Supplementary Information for Development Control Committee

21st June 2016

Application Numbers: 2015/2704/P, 2015/7168/L

Address: Central Somers Town, Covering Land At Polygon Road Open Space, Edith Neville Primary School 174 Ossulston Street And Purchase Street Open Space, London NW1

Image 1 – photo of blimp from Euston Road, above the St Pancras Station (Barlow train shed)

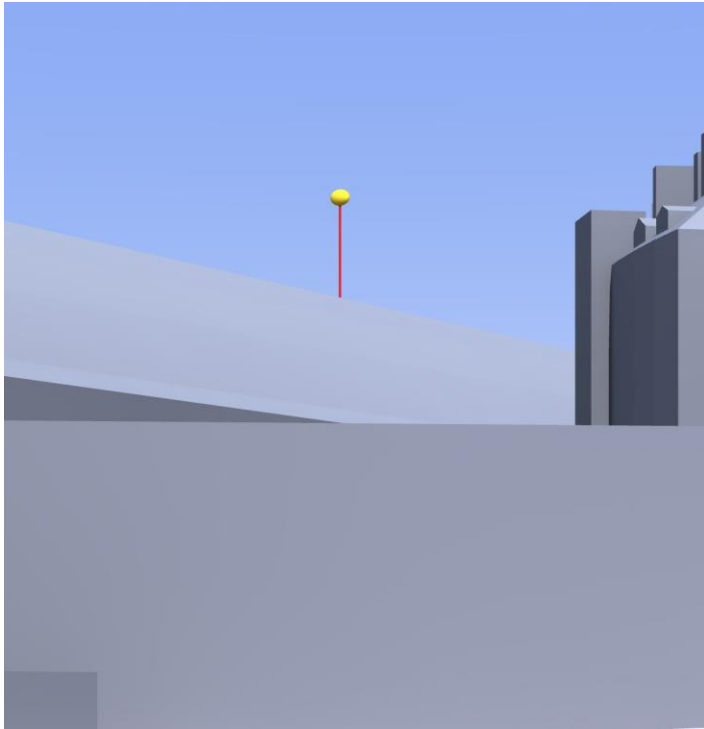
A third party paid for a blimp to be erected to demonstrate the height of the proposed tower on Brill Place. Planning officers did not consider that a blimp was necessary or useful in determining the impact from the tower, as they do not provide an accurate impression of the proposed building, and that this is done much better by CGIs submitted by the applicant. The planning inspector for the 100 Avenue Road appeal decision stated that:

Nevertheless, given that a blimp was erected, officers requested the applicant to verify images of the blimp. The applicant’s consultants have advised that their modelling (Zmapping 3D model) provides a high level of accuracy with a measureable variance of no more than 50cm. In comparing the AOD (Above Ordnance Datum – i.e. height above sea level) figures for both the proposed tower and the height of the blimp the applicant’s consultants found that the blimp was flying at approximately 23.5m above the top of the proposed tower which translates to approximately 7.5/8 storeys above the proposed 25 storeys.
